**CITY OF SNELLVILLE  
DEPARTMENT OF PLANNING & DEVELOPMENT  
MAYOR AND COUNCIL**

**CASE SUMMARY**

**CASE NUMBER:** RZ 20-01 CUP 20-01

**DEVELOPMENT/PROJECT:** Floral Shop & Auto Service and Repair Shop

The proposed site plan, submitted by the applicant.

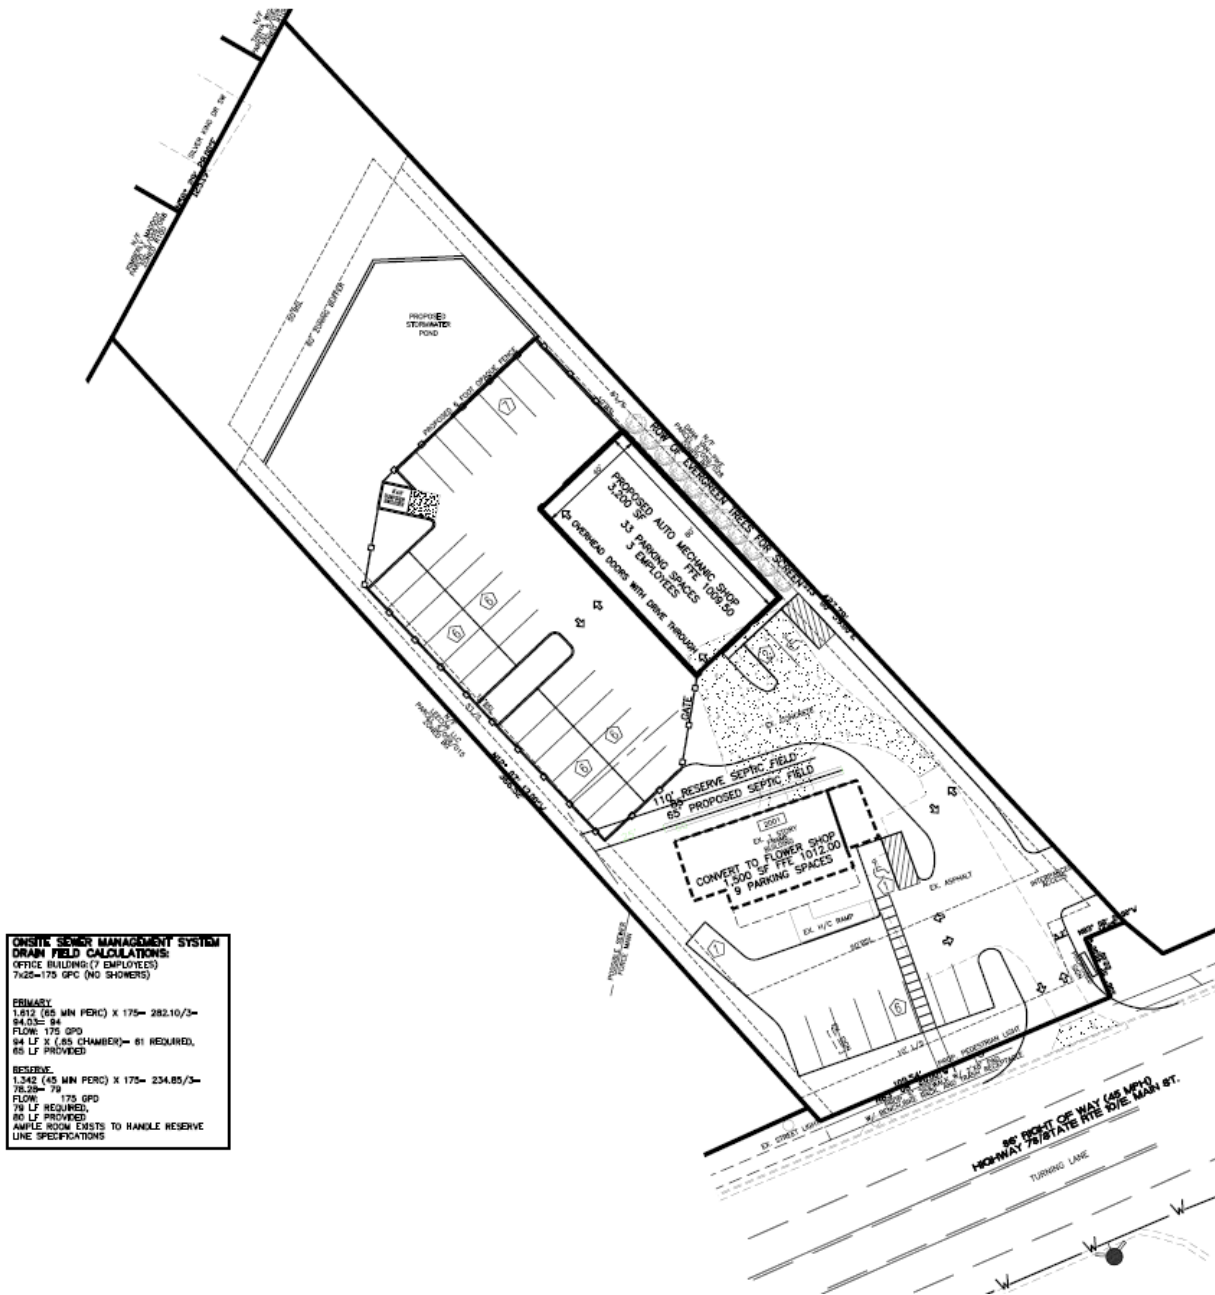
The existing structure is located in the southern portion of the property, and is setback approximately seventy-eight (78) feet from the US-78 / E. Main Street right-of-way. Improvements to the existing parking area include seven (7) parking spaces and one (1) handicap parking space located in front of the existing building.

The rezoning site plan shows a proposed five (5) foot wide sidewalk with small amenity pad for a pedestrian bench, trash receptacle and bicycle rack. One pedestrian light is shown adjacent to the amenity pad. Pedestrian connectivity between the sidewalk and entrance to the existing building is provided by a five (5) foot wide hatched walkway in the parking lot with a concrete walkway connection from the parking lot curb to the sidewalk. Although the applicant is proposing construction of a five (5) foot wide sidewalk along the right-of-way, in 2010 the adjacent property to the west (Future Services) was required to install a six (6) foot wide sidewalk per the City Code, so continuation of the six (6) foot wide sidewalk for this project will also be required (see Condition #7).

Although no monument sign drawings have been provided by the applicant, there is a proposed sign shown just east of the full-access drive. The final sign location may vary in order to comply with the sign ordinance requirements for sign type, sign area, sign height, and sign setback from the right-of-way.

An inter-parcel access stub is shown just to the east of the full-access drive that could provide future connectivity to the adjacent Family Tree Nursery property should they choose to make the final connection.

There is a two-way driveway that provides vehicle access to a 3,200 sq. ft. proposed auto mechanic shop and related parking. Two (2) parking spaces are shown in front of the proposed building with the majority of the parking to the side and rear of the proposed building. There are seven (7) spaces in the rear of the building and twenty-four (24) spaces along the side

property line comprised of two (2) stacked double-rows containing twelve (12) parking spaces each.

The site plan shows sixty-five (65) feet of proposed septic system drain field with an additional one-hundred-ten (110) feet of reserve strip for future septic use. The nearest sanitary sewer manhole is located to the west approximately four-hundred-twenty-five (425) feet from the property line, well outside the threshold requiring connection to sanitary sewer.

One dumpster pad and enclosure is shown in the northwest corner of the mechanic shop parking lot. Although there is no dumpster pad and enclosure shown for the existing building, one shall be required to serve the future flower shop or other tenant use (see Condition #2). The code requires these enclosures to be eight (8) feet in height and made of brick, stucco, or split-face block.

Although no detail has been provided nor shown on the colored rendering, there is a proposed six (6) foot high opaque fence with gate will enclose the main parking area of the auto mechanic shop for security and screening of vehicles that are parked or stored outside.

There is a proposed stormwater detention pond located behind the auto mechanic parking area which includes a concrete retaining wall.

There is a sixty (60) foot undisturbed buffer shown that separates the proposed commercial use from the two residential lots of the Saddle Club Estates subdivision. Combined with the stormwater detention pond location, the proposed auto mechanic shop is approximately one-hundred-sixty-two (162) feet from the rear property line and the Saddle Club Estates subdivision.

1. The property shall be developed according to the site plan entitled “Rezoning Plan & CUP Plan for 2001 Main St. East”, dated 11-30-2019 and stamped received 1-14-2020, with modifications permitted due to engineering restraints, ingress and egress, and/or to meet conditions of zoning or State, County, and City regulations.

2. Applicant shall provide a separate dumpster pad and enclosure constructed in accordance with Sec. 19-34 of the City Code for use by the existing building tenant and shall be located in close proximity to the existing building.

7. New sidewalks shall be a minimum of six (6) feet in width.
8. Vehicle sales from or on the property are prohibited.
